City of Portland, Maine – Building or Use Permit Application 389 Congress Street, 04101, Tel: (207) 874-8703, FAX: 874-8716

Location of Construction: 1 Canal Plaza 5th Fl		Owner: Key Bank Plaza Realty		Phone:		Permit No:	
Owner Address: 1 Canal Plaza Pld 04101		Lessee/Buyer's Name: Maine Stay Holdings		Phone:		BusinessName:	
Contractor Name: ** Wright@Ryan Construction		Address: 10 Danforth St Pld 04101		Phone: 773-3626		Permit Issued:	
Past Use: Office		Proposed Use: Same		COST OF WORK: \$ 20,000		PERMIT FEE: \$ 120.00	
Proposed Project Description: Rehab Interior Office Space		FIRE DEPT. <input checked="" type="checkbox"/> Approved <input type="checkbox"/> Denied		INSPECTION: Use Group: B Type: 13 DOCA 96		Zone: CBL: 032-1-036	
		Signature: [Signature]		Signature: [Signature]		Zoning Approval: 4/2/99	
Permit Taken By: S MG		Date Applied For: February 2, 1999		PEDESTRIAN ACTIVITIES DISTRICT (P.A.D.)		Special Zone or Reviews:	
		Action: <input type="checkbox"/> Approved <input type="checkbox"/> Approved with Conditions <input type="checkbox"/> Denied		Signature: Date:		<input type="checkbox"/> Shoreland <input type="checkbox"/> Wetland <input type="checkbox"/> Flood Zone <input ty

MAINE STAY HOLDINGS
FIFTH FLOOR
DATE: JANUARY 11, 1999
SCALE: 1/8" = 1'-0"

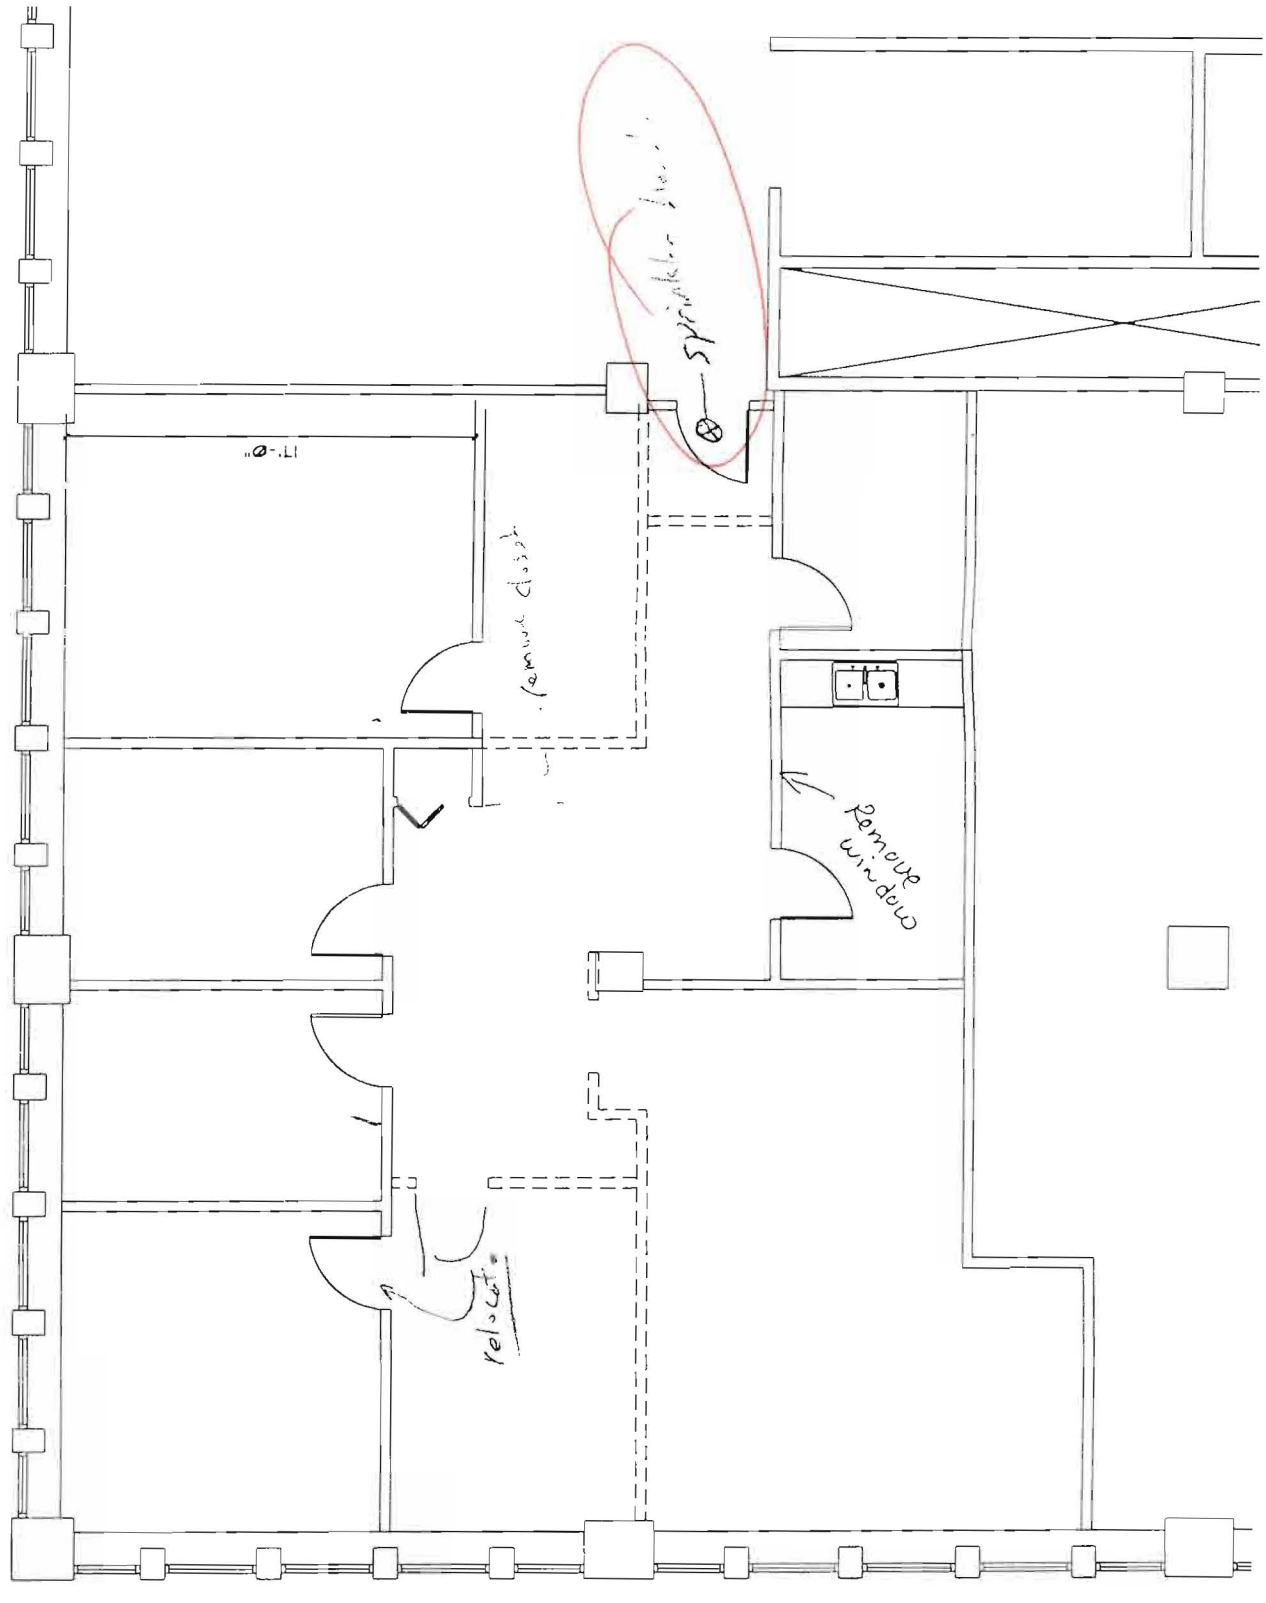
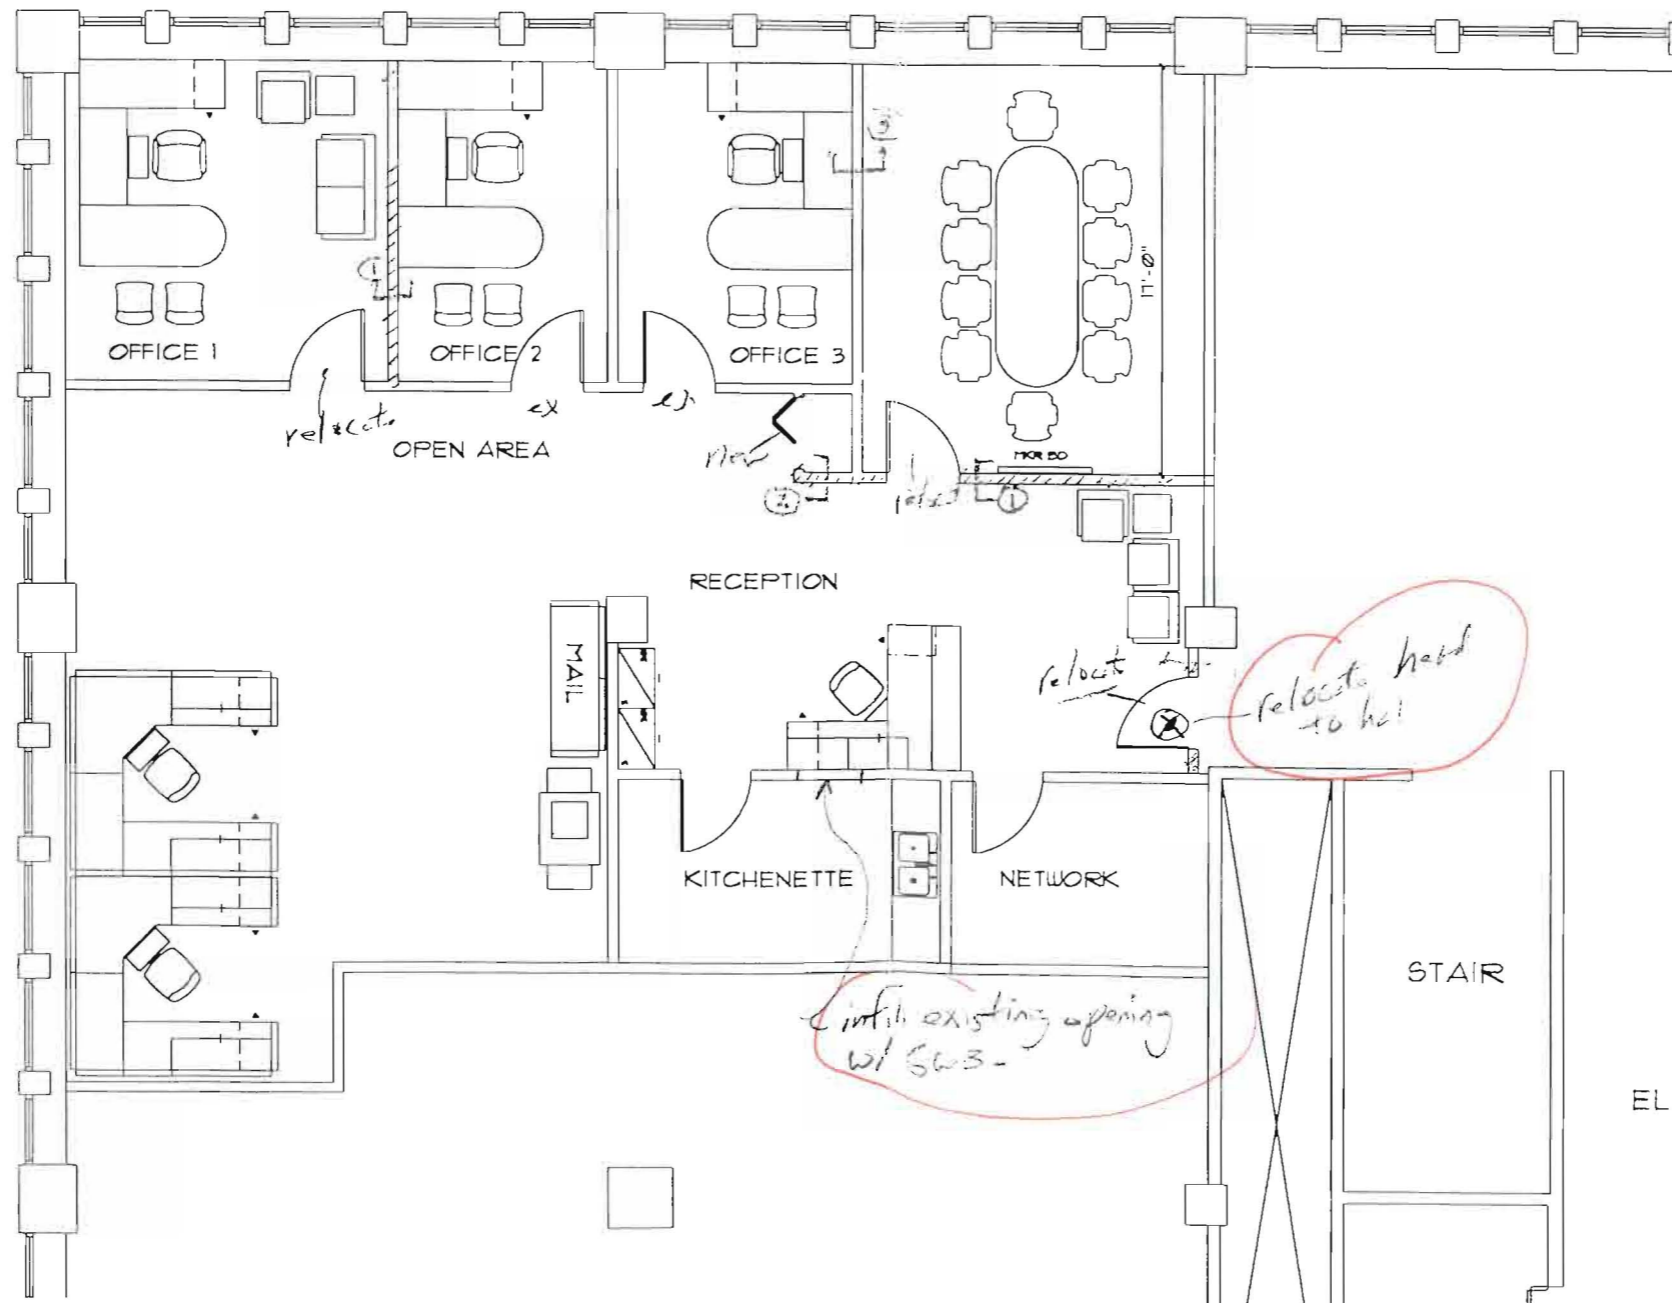
2/15/99 Question on fire rated doors. Are they needed
if sprinkler covered? or
3/16/99 Does not need fire rated doors because of sprinklers.
10/15/01 o.c.'s not c/o needed.

31. Sprinkler system shall be extended into renovated space
